Biala Wind Farm Transmission Line Connection and Substation Upgrade

**Submission to Upper Lachlan Shire Council in response to
JRPP Deferral Submissions**

Newtricity Developments Biala Pty Ltd

June 2018

Land Boundary Survey (June 2018)

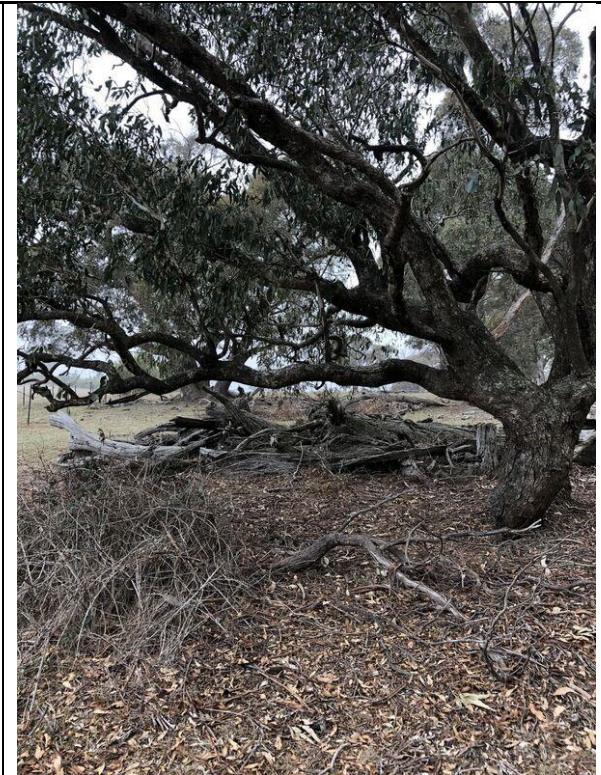
Submission Issue	Response
Biodiversity	
<p>The alignment has avoided areas of Tablelands Snow Gun, Black Sallee, Candlebark and Ribbon Gum Grassy Woodland (EEC) along the transmission line alignment, however a large patch of intact forest has not been avoided even though alternative options appear to be available.</p> <p>OEH has reviewed the alignment and requires further justification and clarification</p>	<p>The Biala Wind Farm Transmission Line Connection and Substation Upgrade Project (the Project) will enable the Biala Wind Farm to deliver the environmental, economic and social benefits outlined in the Biala Wind Farm EIS. It will connect the Biala Wind Farm to the existing electricity grid, thereby facilitating supply of renewable energy to supplement NSW and National energy requirements and assist in reducing greenhouse gas emissions.</p> <p>As part of Project design development, numerous connection options and transmission line design alternatives have been investigated since 2013. During preparation of the Preliminary Environmental Assessment for the associated Biala Wind Farm Project in 2013, broad potential corridors for the transmission line were identified, which included connection to the Yass to Goulburn 132 kV line via an on-site substation and a 22km overhead transmission line. Further investigations undertaken for the SoEE identified the current underground transmission line alignment and</p>

<p>as to why this patch has not been avoided. OEH has provided two options for the design alignment that would be more appropriate in avoiding the impacts.</p>	<p>design as the most viable connection option with the least environmental impact. Refer to Section 2.6 of the SoEE for further information.</p> <p>Since the preparation of the SoEE, detailed design development has further reduced environmental impact through an iterative process informed by further site investigations, detailed land boundary surveys and refinement of construction methodologies. A summary of this process is provided below and provides clear justification as to the final design and route alignment, and confirms that alternative options as suggested by OEH have been duly considered.</p> <p>The SoEE proposed a 20m disturbance area for the transmission line inside a 100m wide corridor. The final location of the 20m corridor inside the 100m corridor was to be determined prior to commencement of construction.</p> <p>Detailed Design Development (March 2018)</p> <p>As noted in ERM's <i>Submission to Upper Lachlan Shire Council in response to JRPP Deferral Notice</i> (April 2018), the detailed design alignment was defined on-site by a team using their environmental and engineering expertise to minimise environmental impact without compromising constructability. The 100m micro-siting corridor proposed in the SoEE was narrowed to a disturbance area of 20m.</p> <p><u>Humes Creek Crossing</u></p> <p>The detailed design alignment followed the previous alignment for the majority of the route. However, at the Humes Creek Crossing, the SoEE proposed two transmission line alignment options due to the complexity of design for HDD. During detailed design development, the northern alignment was confirmed as the preferred option to avoid impacts to the EEC and heritage sites which lie on the southern alignment option.</p> <p><u>Gurrundah Creek Crossing</u></p> <p>To the east of the Gurrundah Creek Crossing, due to the proximity to a non-involved landowners' property boundary, the alignment was modified by moving it slightly to the south and the removal of individual trees on the edge of the Tablelands Snow Gum, Black Sallee, Candlebark and Ribbon Gum Grassy Woodland (EEC) to the east of the creek are unavoidable. This section of the alignment is constrained by a number of factors.</p>

- OEH Option 1 (Southern) – This alignment would traverse prime agricultural land of which no landowner agreement is in place. Therefore the land is not within the current Transmission Line DA. This alignment would cross Gurrundah Creek at a location where it is more likely to be flowing, so potential water quality and hydrology impacts would be greater.

- OEH Option 2 (Northern) - This alignment would traverse farm land of which no landowner agreement is in place. Therefore the land is not within the current Transmission Line DA. The landowner is strongly opposed to the Transmission Line DA and the approved Biala Wind Farm. This alignment would also cross Gurrundah Creek at a location where it is more likely to be flowing, so potential water quality and hydrology impacts would be greater.

- Developments Biala Alternative Option 3 (TransGrid 330kV Easement) – Developments Biala has taken OEH’s concerns seriously and has investigated a potential option 3, where the alignment would pass along TransGrid’s 330kV overhead transmission line easement. This option requires the cable passing across prime agricultural land, or passing through another EEC. TransGrid is not in favour of locating the cable in their easement due to technical, security of supply, safety and legal reasons. This piece of TransGrid’s infrastructure is very important to security of electricity supply to Sydney.

Careful design of the alignment has successfully avoided areas of Tablelands Snow Gun, Black Sallee, Candlebark and Ribbon Gum Grassy Woodland (EEC) along the 12km long transmission line alignment. Only one large patch of intact forest cannot be avoided and has been clearly documented by ERM in the SoEE (and supporting Ecology Impact Assessment, Annex B) (November 2017) and the *Submission to Upper Lachlan Shire Council in response to JRPP Deferral Notice* (April 2018). A detailed land boundary survey was undertaken to the east of Gurrundah Creek Crossing on 5 June 2018. The purpose of the survey was to more accurately define the exact land boundary so that the alignment could be refined to reduce impacts to the EEC. In response to OEH’s concerns, Developments Biala has further discussed this section of the route with Marais Laying Technologies (Marais). On the basis of these discussions, Developments Biala commits that tree felling activities along this 200 m section of the alignment will be contained within a 15m corridor. This narrowing is possible over this short distance and further reduces impacts to the EEC.

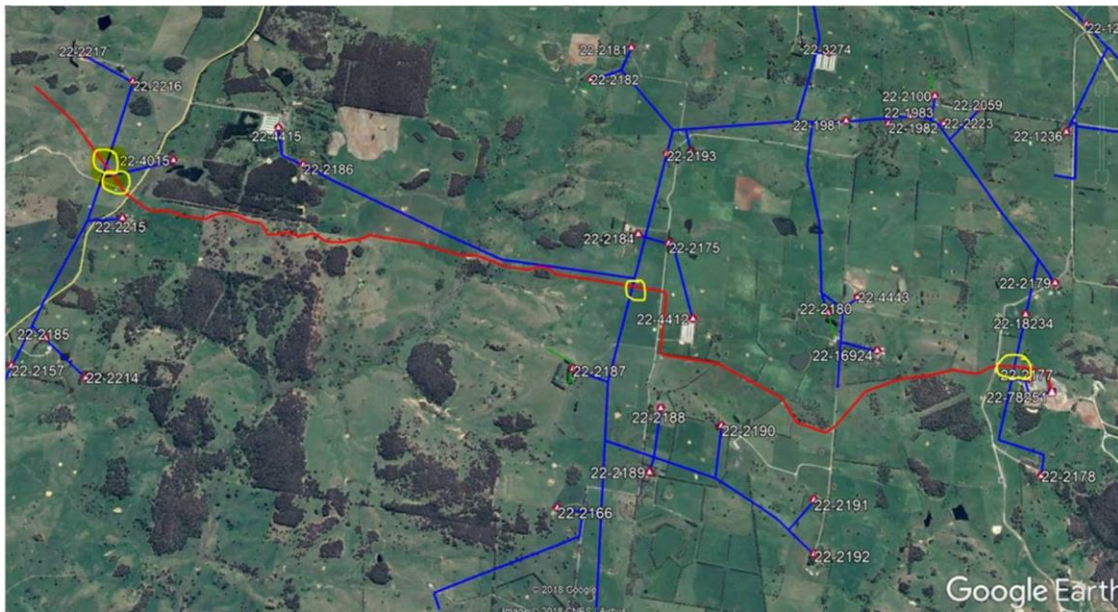
Following Essential Energy's email submission to ULSC on 29th May sent by Fiona Duncan, Developments Biala has contacted Essential Energy (EE) to discuss the proposed development. EE has provided Developments Biala with GIS data showing the location of their existing assets. Four locations have been identified where the Transmission line will cross under EE's overhead powerlines as per the following image:

These locations have been discussed with EE's Asset Management team. EE have provided further advice to Developments Biala on requirements in order to work in their existing powerline easements.

- a. There will not be any alterations to the existing ground level for the proposed development.
- b. Developments Biala notes that Essential Energy will retain uninterrupted access to its infrastructure.
- c. Developments Biala's Construction Contractor will maintain safe working distances while building or operating machinery near any powerlines. (Refer to Workcover regulation 2001 Chapter 4 Division 8 and relevant Workcover Codes of practice for these safe working requirements/ SafeWork NSW Code of Practice – Work Near Overhead Powerlines)
- d. Developments Biala will install signage indicating the location of any underground cables installed across land subject to EE powerline easements.
- e. Developments Biala confirms that GPS coordinates of crossings will be supplied to Essential Energy so that the assets can be mapped and notations made on internal operational applications.
